## **Addendum 1 for RFB 938601-01**

Project Name: DOC ASP Tunnel Repairs

RFB #: 938601-01

Date: 12/5/2024

**D1** CONSTRUCTION JOINT  
1 1/2" = 1'-0"

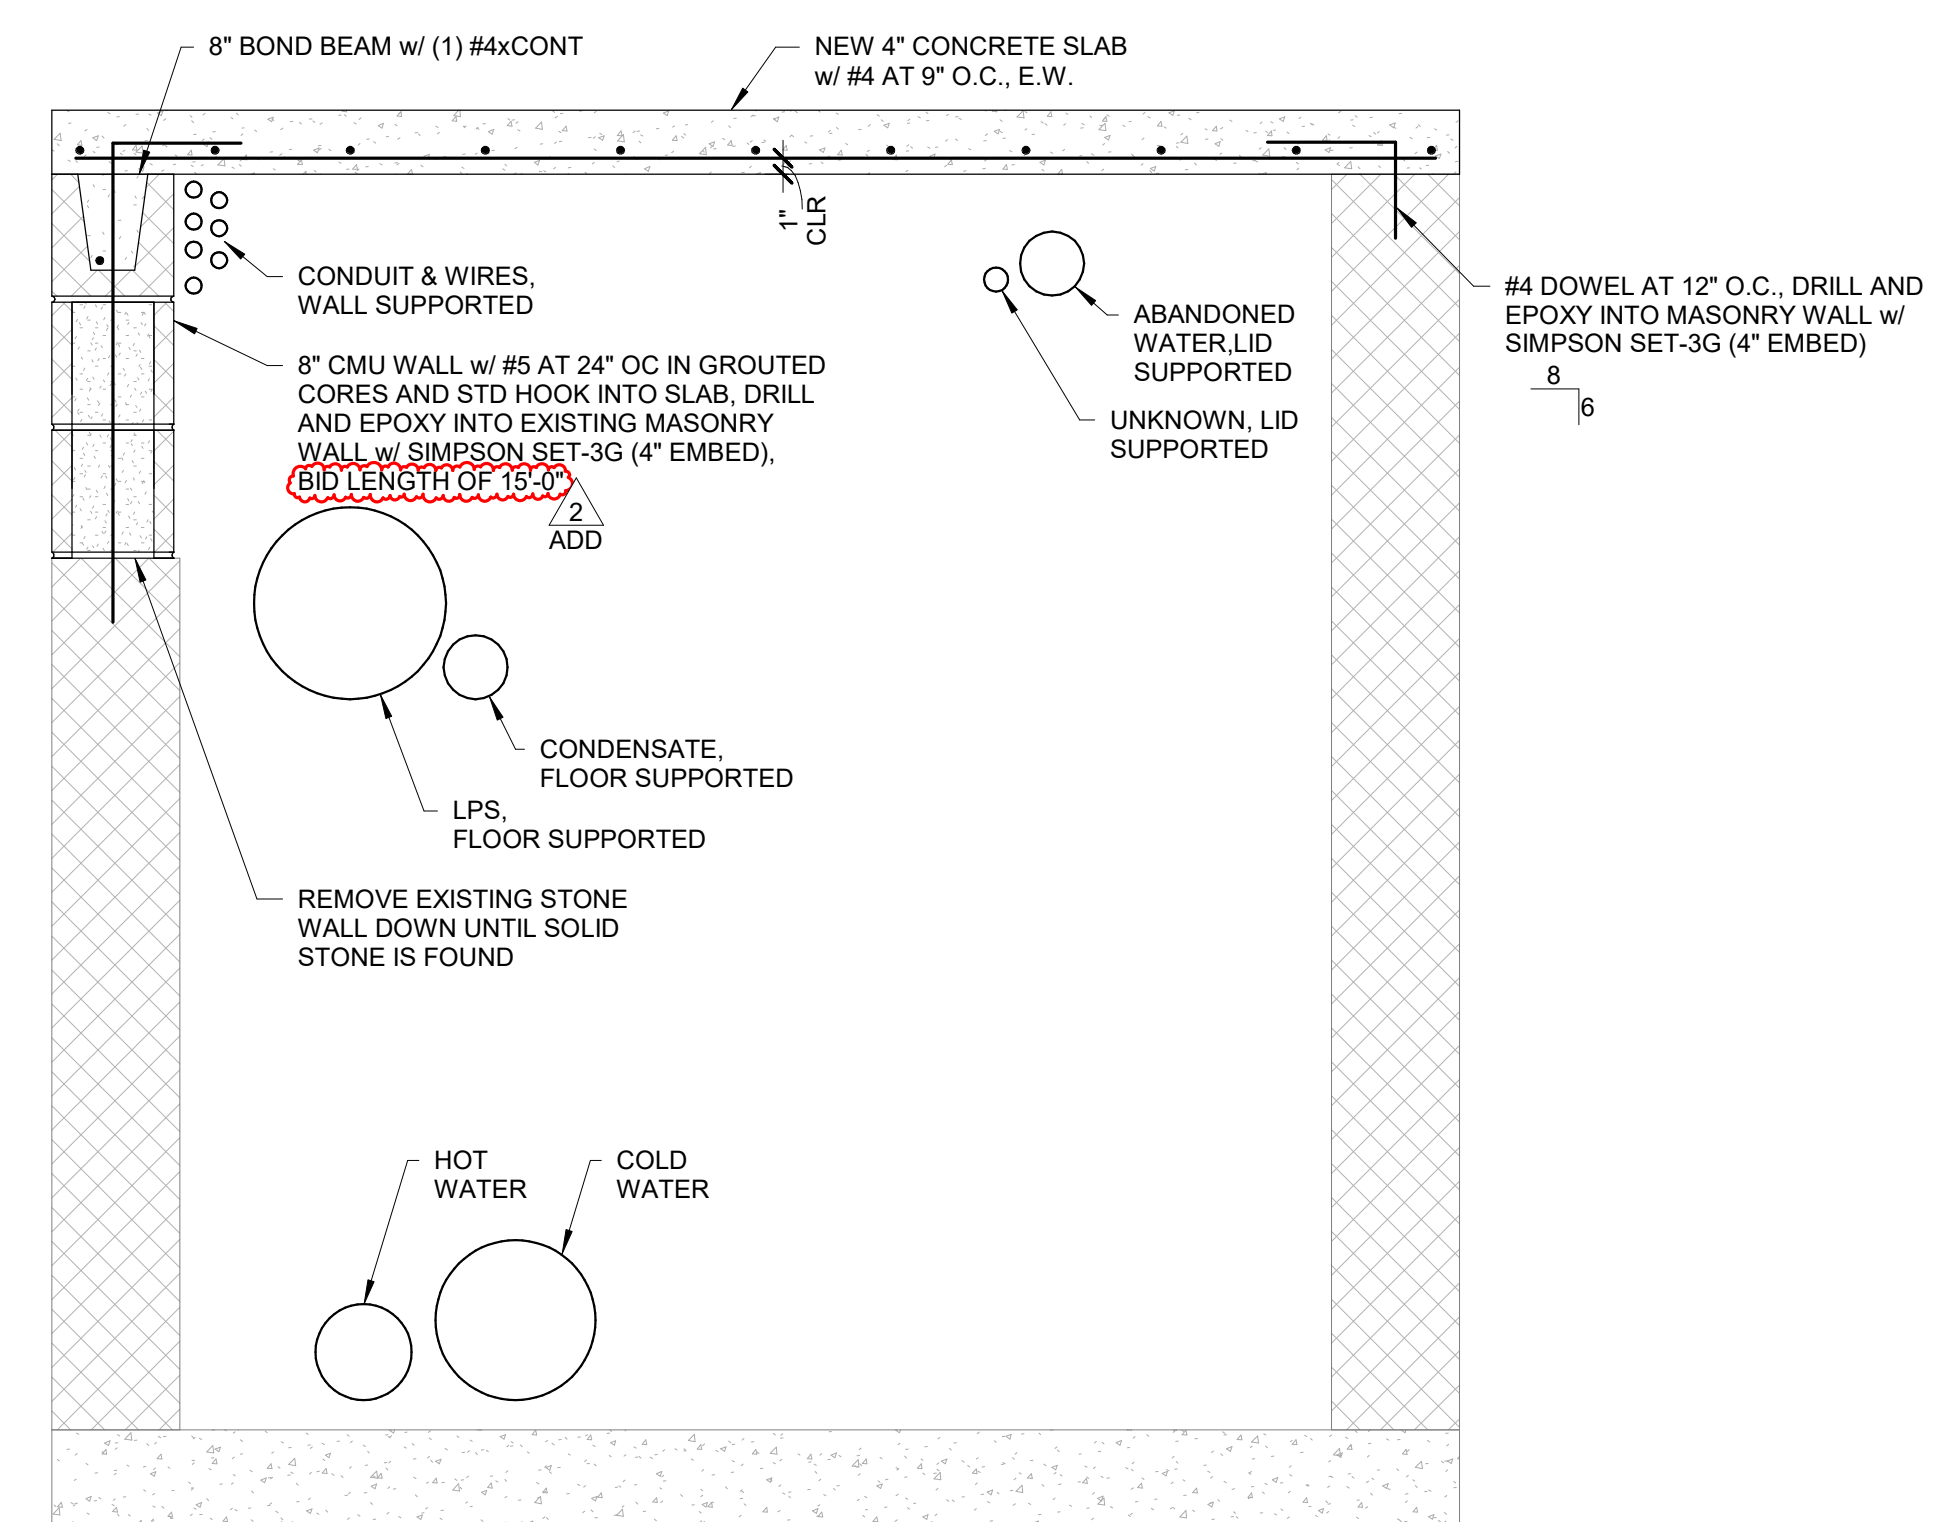
- Cold Joints or Caulk joints at location for 8' sections?
  - Shive to provide detail in Addendum.
- Concrete testing requirements for the pours?
  - It was determined that testing could be performed at the beginning, middle and end of each tunnel location (North section and South Section).

1. No submitted questions following Pre-Bid Meeting received from [construction.procurement@iowa.gov](mailto:construction.procurement@iowa.gov)
2. See attached Meeting Minutes & Sign In Sheet from the November 18<sup>th</sup> and November 21<sup>st</sup> Mandatory Pre-Bid Meetings.
3. Tunnel Map provided by Boyd H. During Pre-Bid Meeting.
4. Photos Attached of ASP Tunnel
5. Attached is Shive-Hattery Addendum #01 Sheet Changes and Additional Details
  - i. New S501 Sheet with Joint Detail.
  - ii. New S102 Sheet including South Tunnel cut section.
